*Revised* AGENDA

LANDMARKS PRESERVATION  
ADVISORY BOARD  
OAKLAND, CA 94612

December 8, 2014

**RE: The Bureau of Planning's preliminary design comments on Children's Hospital and Research Center Oakland (CHRCO) Master Plan Application**

Patient Pavilion & Drop-Off

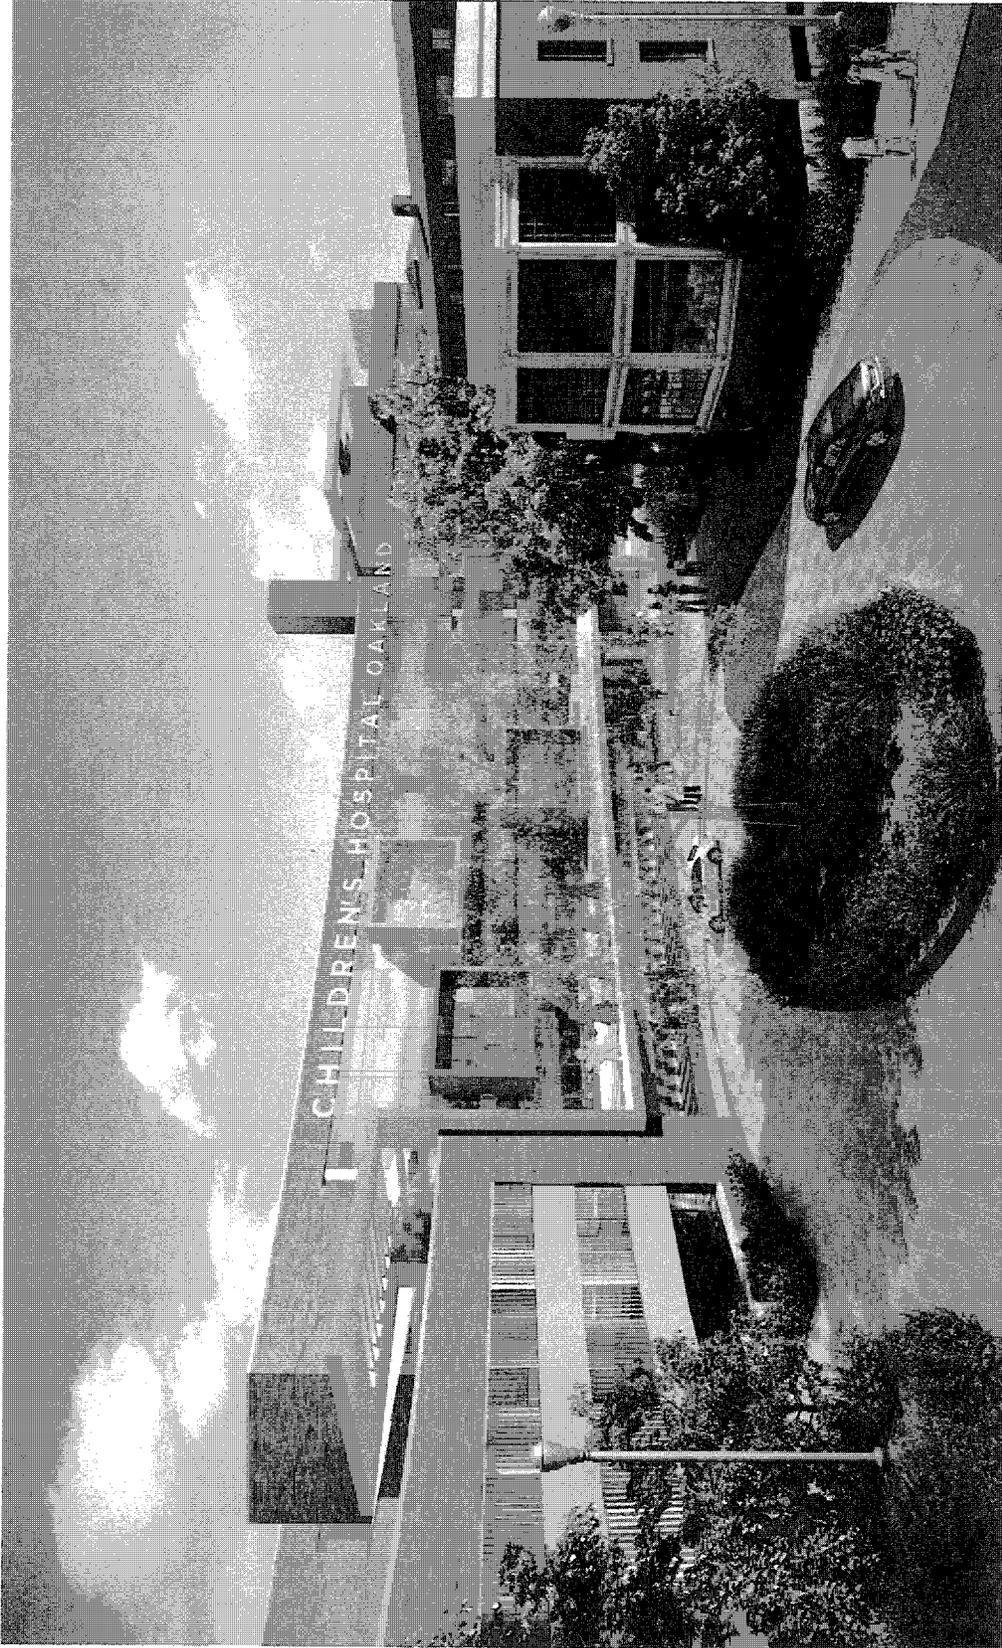
At the November 18, 2013 LPAB meeting, City staff and the LPAB expressed concerns with how the Link Building would relate architecturally to the historic A/B Wing and the more modern Patient Pavilion. Previous renderings had depicted an abrupt change between the glassier Link Building and the brick A/B Wing (See Attachment C page B3.00 and B3.01). In past projects, where a more modern structure is being proposed next to a historic structure, the LPAB and City staff recommended that the new structures relate to but be distinctly different than the historic structure. Staff recommended that the Link Building take cues from the A/B wing's proportions, solid to void space, materials, ornamentation and reinterpret them in modern way.

The Project applicant has continued to revise the design of the Link Building (Attachment D page 20). The façade now provides the visual link that staff was expecting. Specifically, the base of the building continues to be brick and the portion that houses the new exit stair is now also brick-clad. The windows are steel or aluminum-sash and have similar multi-light, vertical proportions as those on the A/B Wing. In addition, the Project applicant is proposing to retain the terracotta frieze and decorative medallions from the B/C Wing and include those on the exit stair tower and below the windows. The Patient Pavilion design incorporates the glazing and mullion pattern from the Link Building (Attachment D page 18-22). Staff has no further concern with the preliminary design of the Link Building or the Patient Pavilion. However, design development should continue for both buildings as part of the Final Planned Unit Development permit for Phase 2.

11. Renderings and elevations of the Family House should clearly show what is occurring with the stairs and garage elements. Design work should continue on the roof line connections.
12. The Patient Pavilion and Link Building should take more cues from the existing A/B Wing in terms of ornamentation and window to brick proportions.

Central Utility Plant

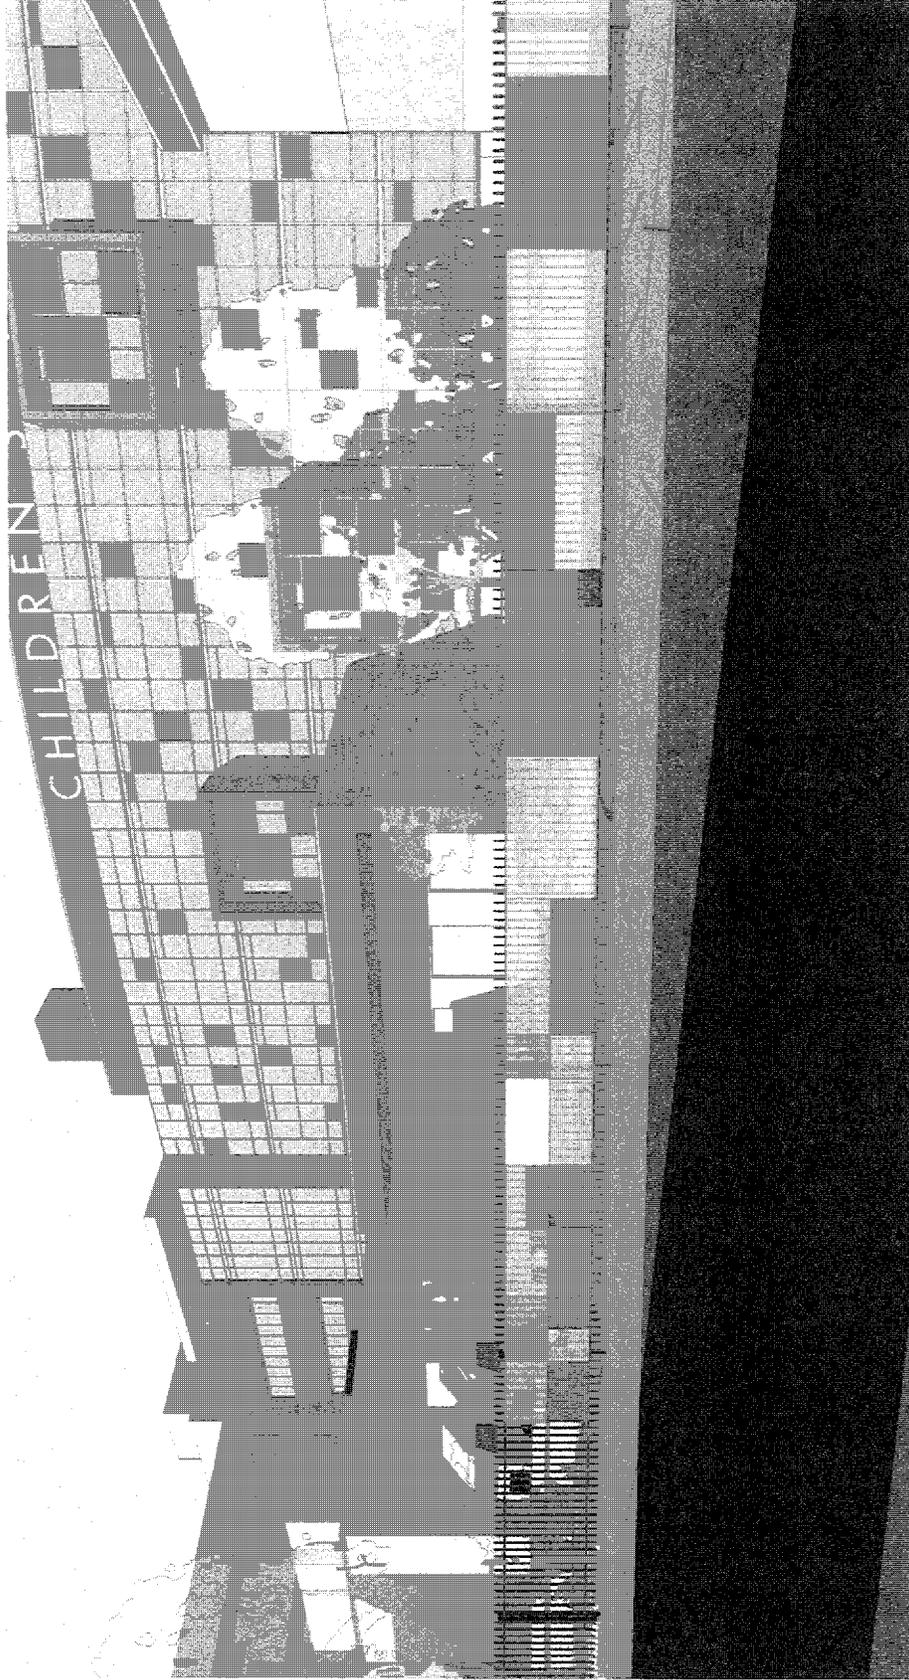
The Central Utility Plant design should provide additional interest to the pedestrian. The parapet should entirely enclose the cooling towers. The louvers or screen should be decorative enough to provide interest and compliment the Patient Pavilion behind the plant. Art, brick, or decorative panels along the base would tie the Plant to the other buildings on campus. If stucco must be used, the expansion joints should be used to provide break down the mass, provide a clear shadow line and additional interest to the building in the same way glass is used on the OPC2 and Patient Pavilion. The Plant should be designed to minimize noise along the sidewalk. The medical gas storage building should be located away from the sidewalk and additional bio-retention plantings with trees to screen the Plant should be installed.

14. All Central Utility Plant equipment in Phase 2 should be located behind decorative screens. The bay should be reduced in width as to not be so prominent from the BART and street. Loading areas should be minimized and additional landscaping installed.
